Engineering has reviewed the plans for the Woodlands Landing at Echo Farms-Tract 3A project submitted February 1, 2019 and have the following comments:

WOODLANDS LANDING AT ECHO FARMS - TRACT 3A

DESIGN DOCUMENTS

PONDS 3.1B-1 & 3.1B-2 POND DETAILS

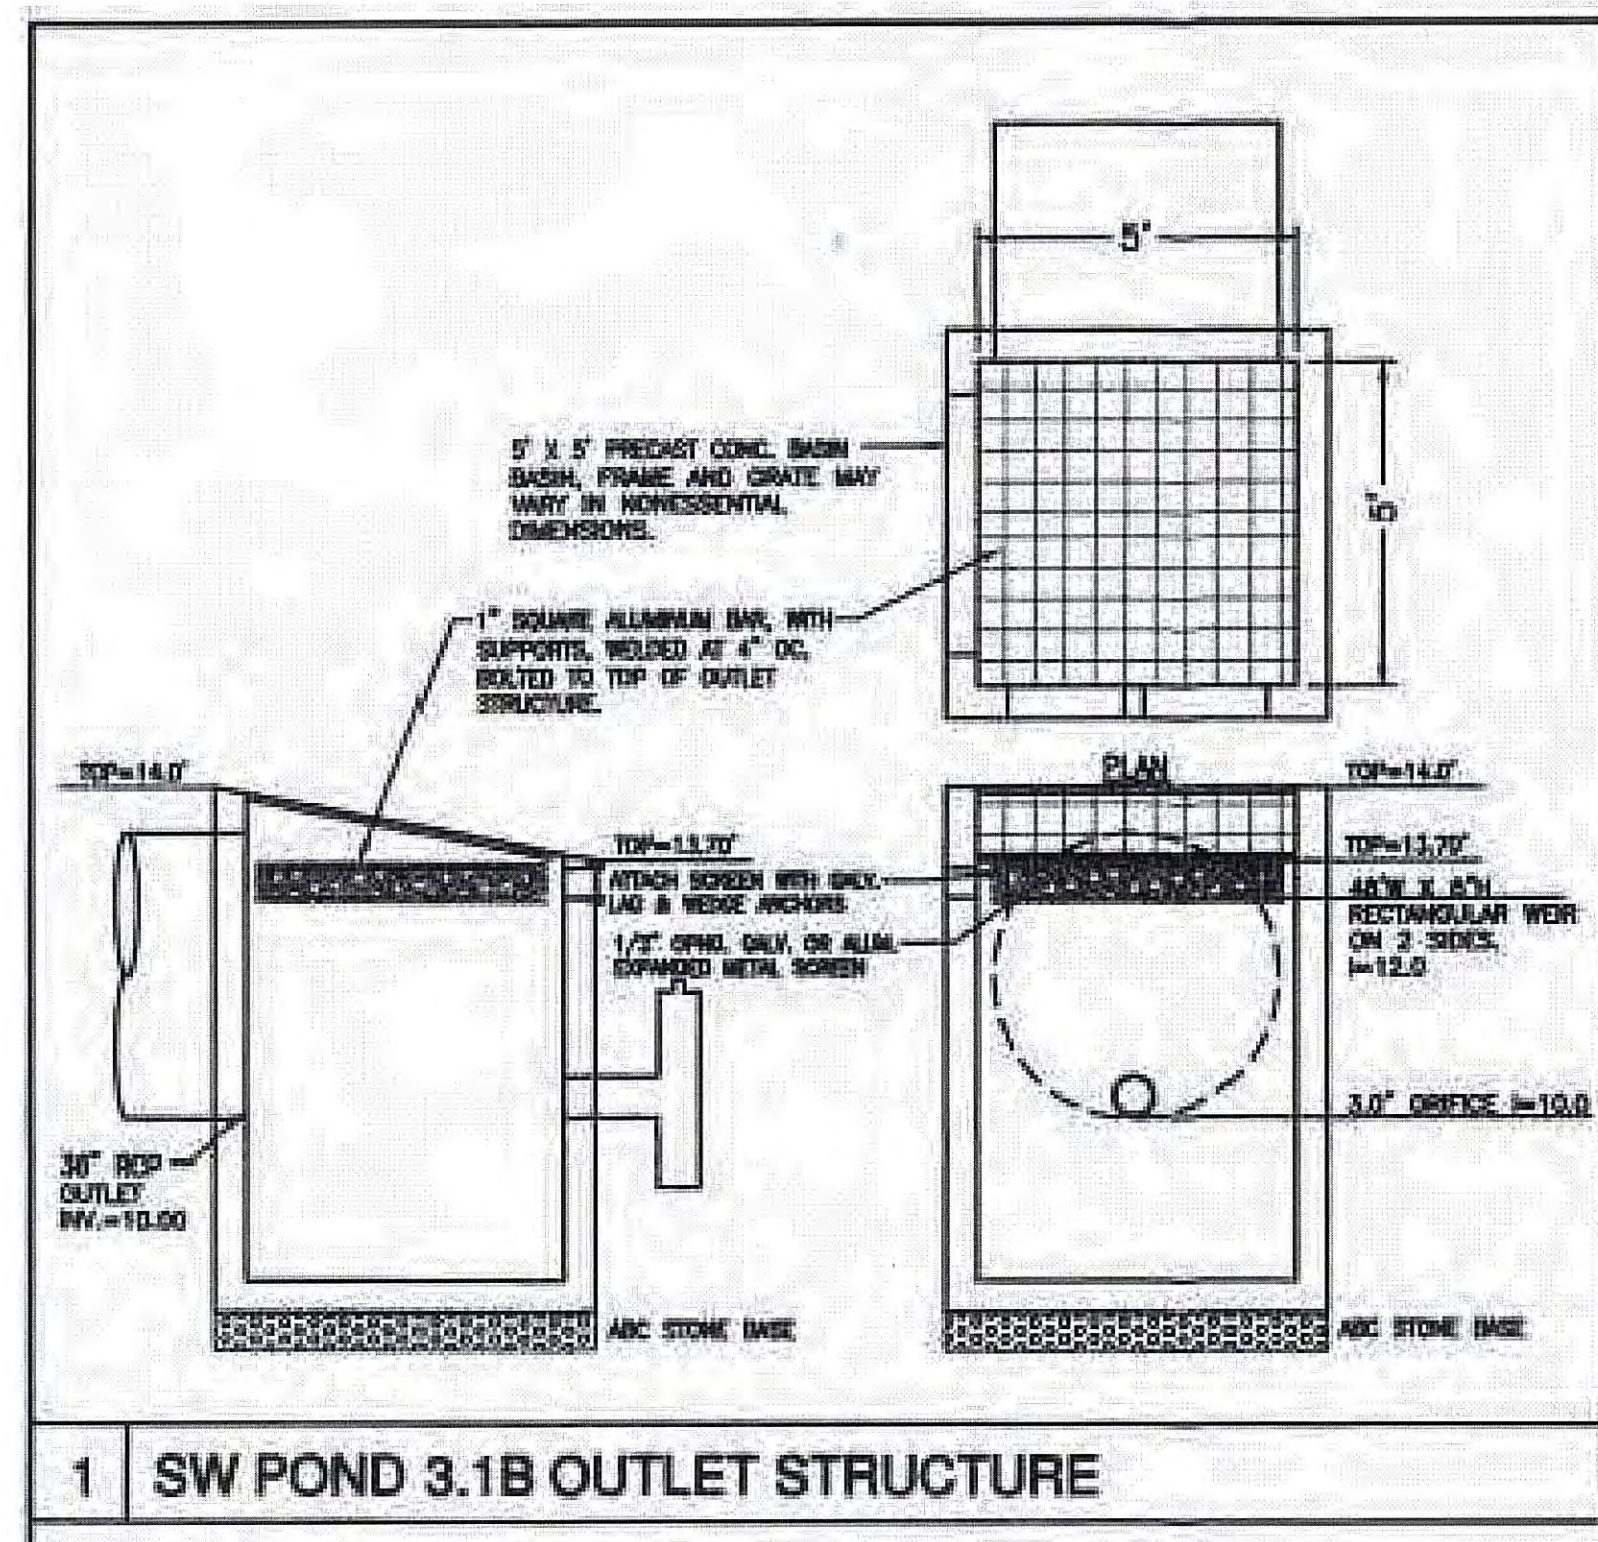
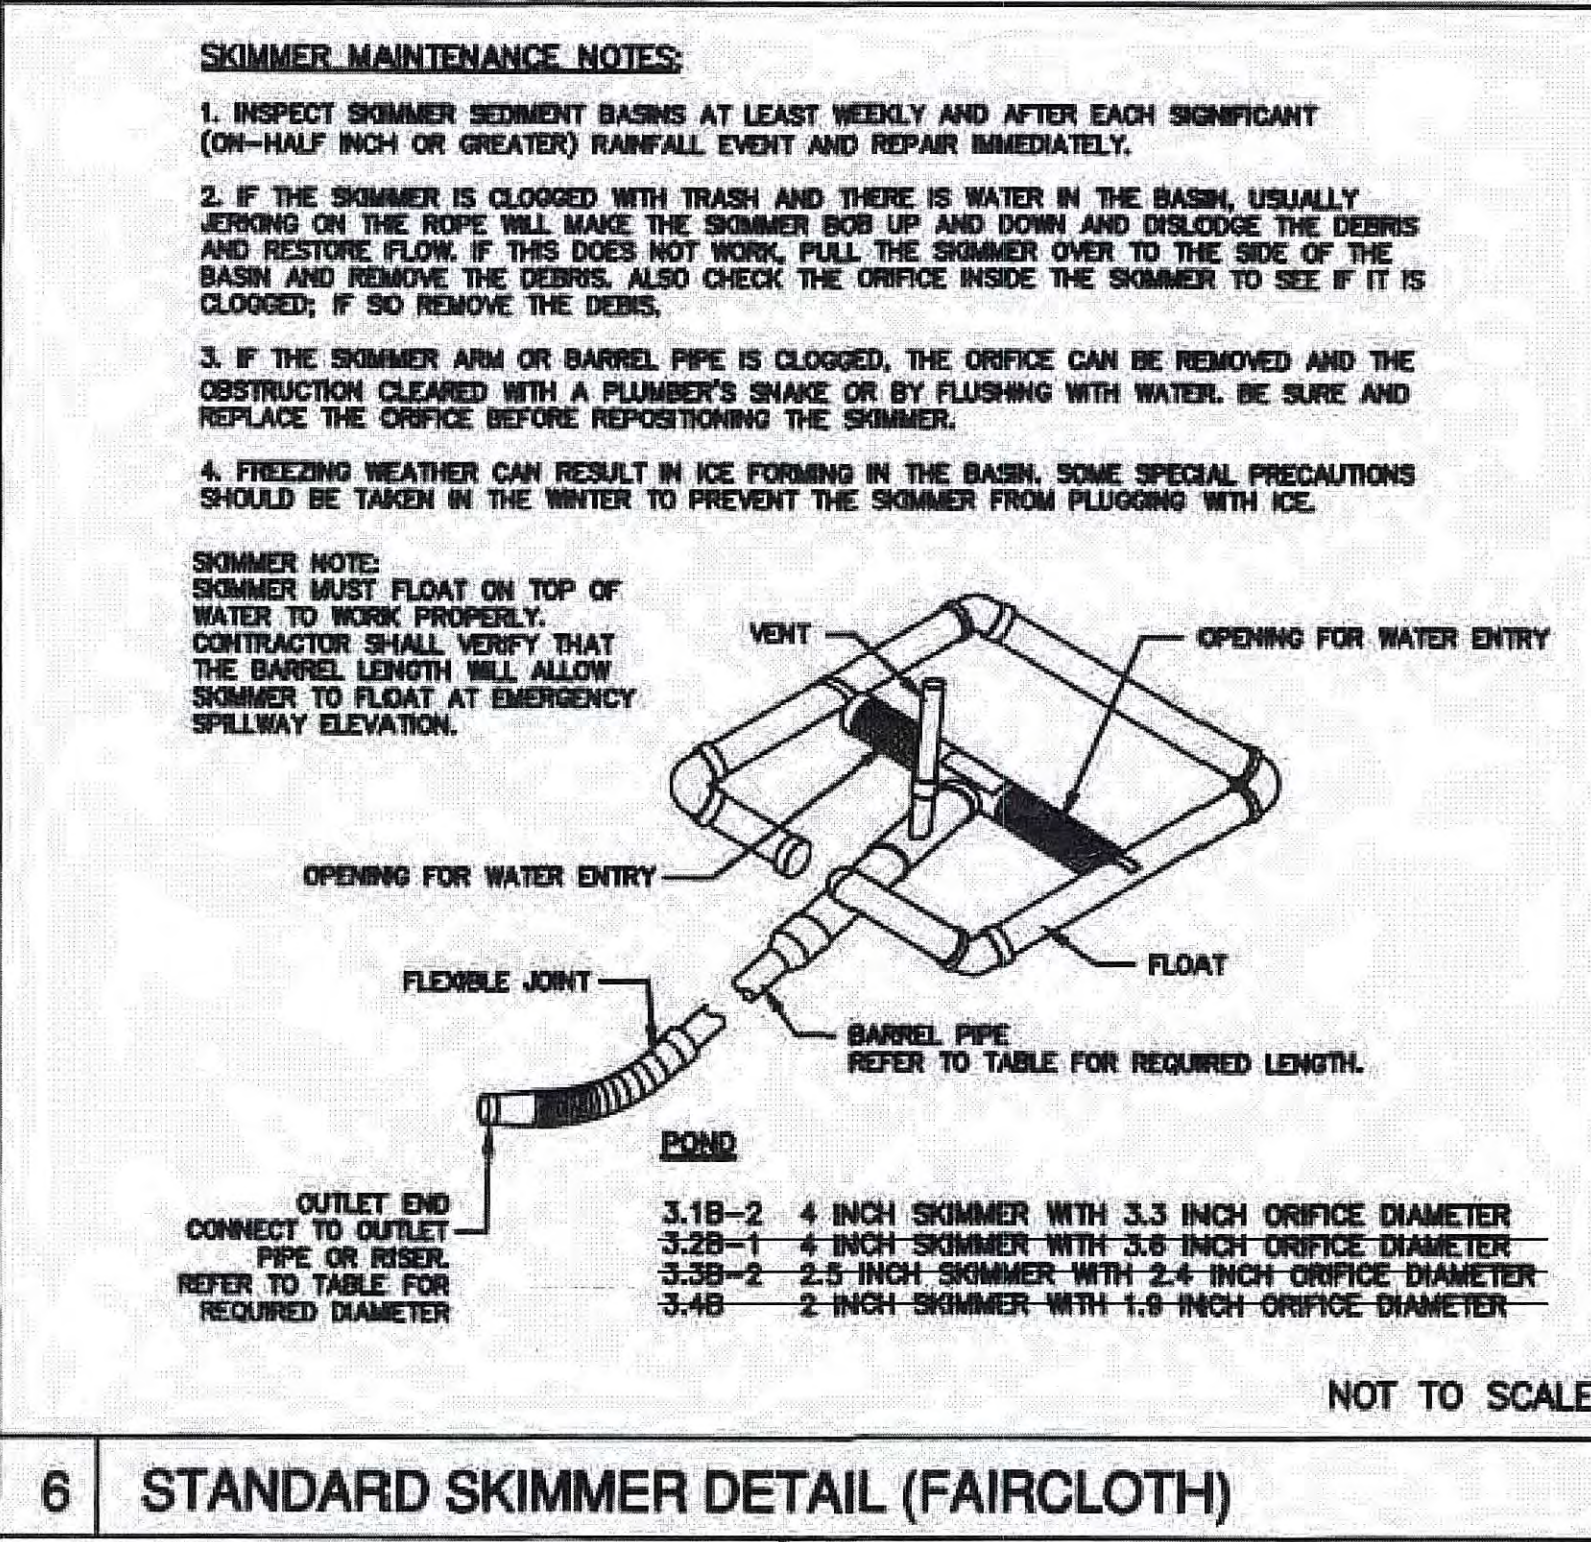
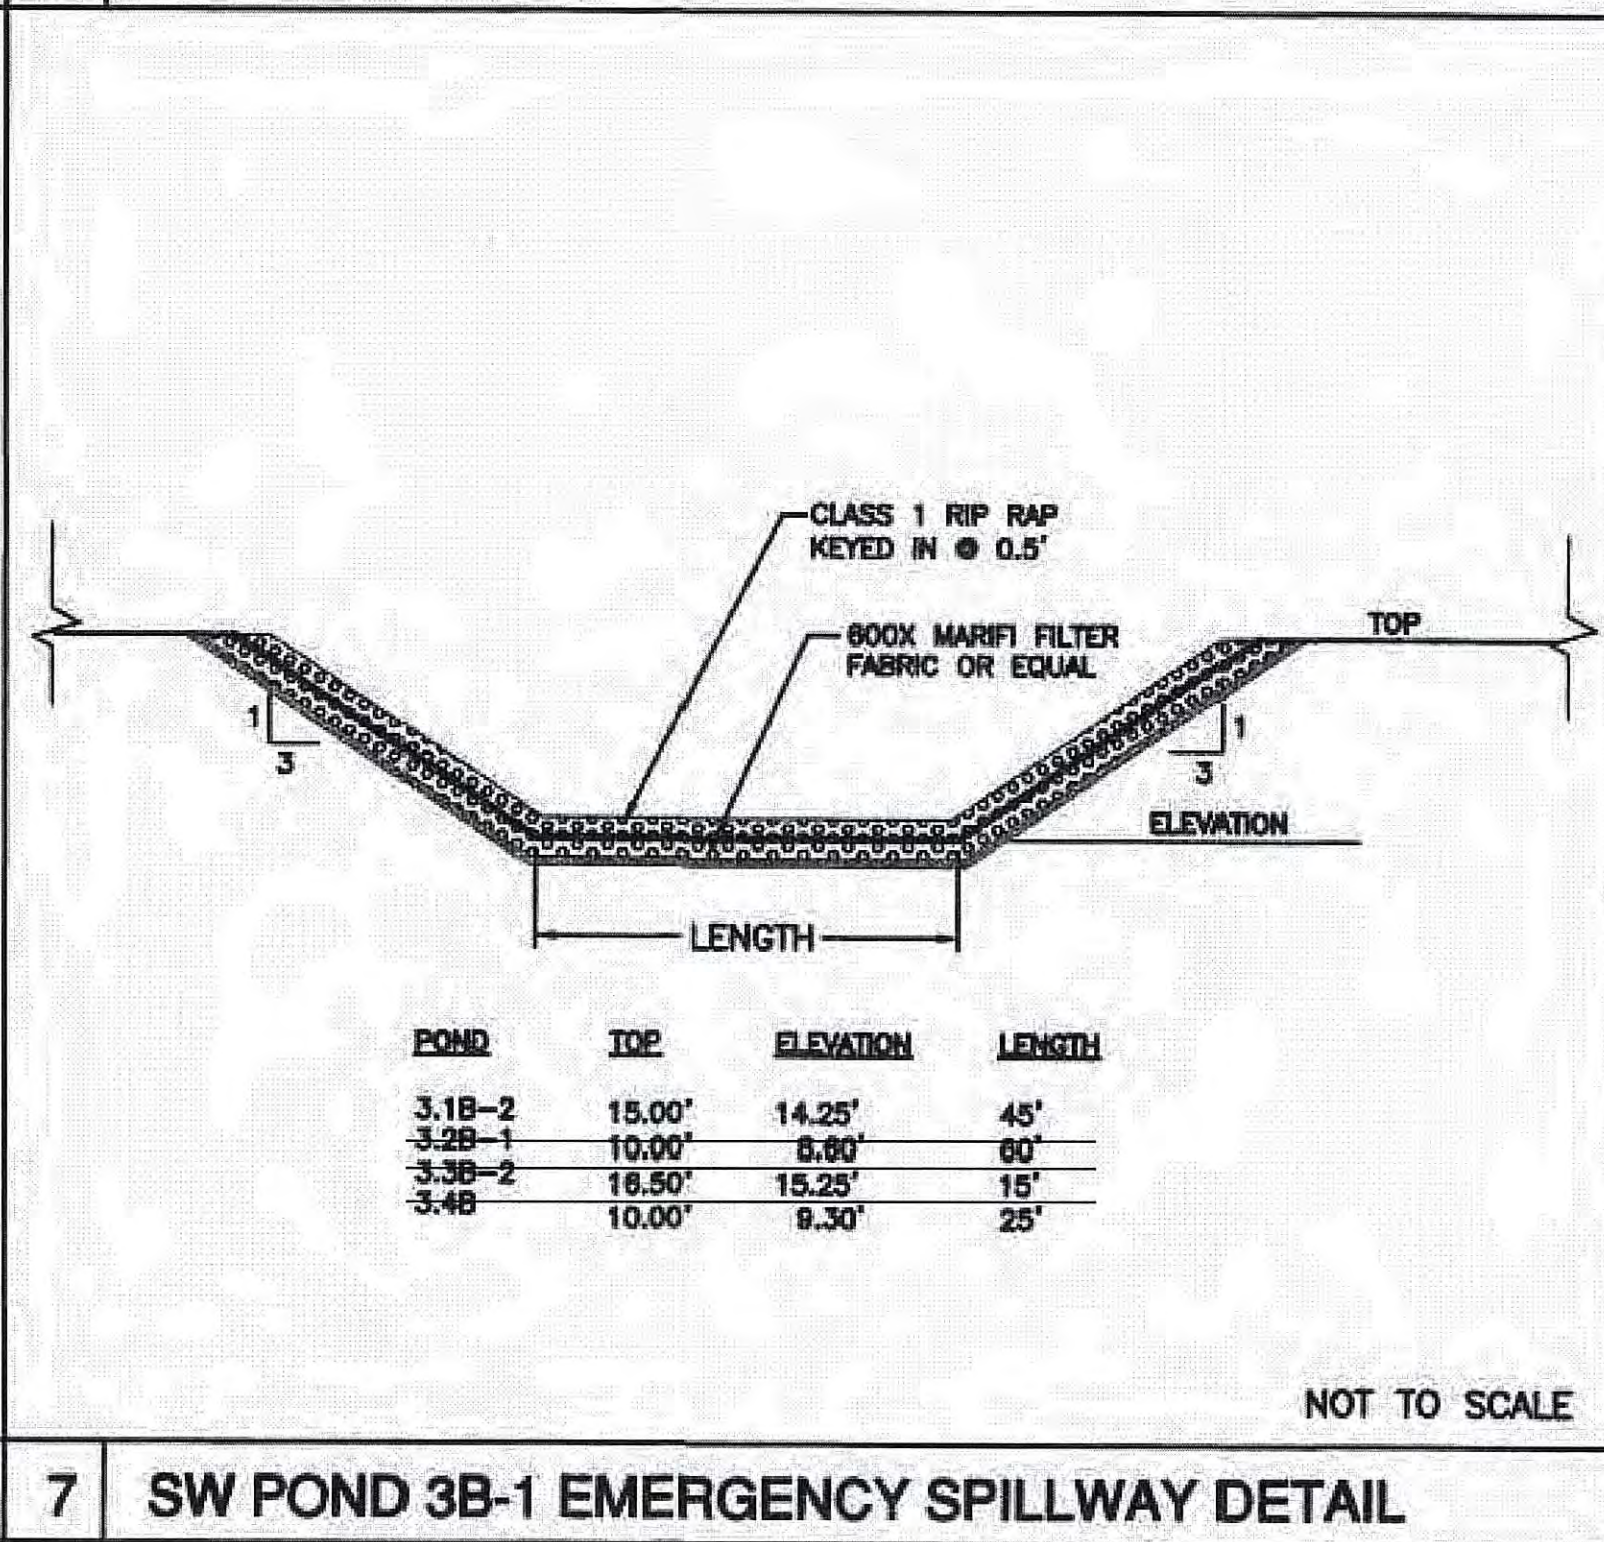
*- Hard to read
- Add plan views and cross-sections from approved 3B plans to this plan set. since 3B.1 is part of 3A now.*
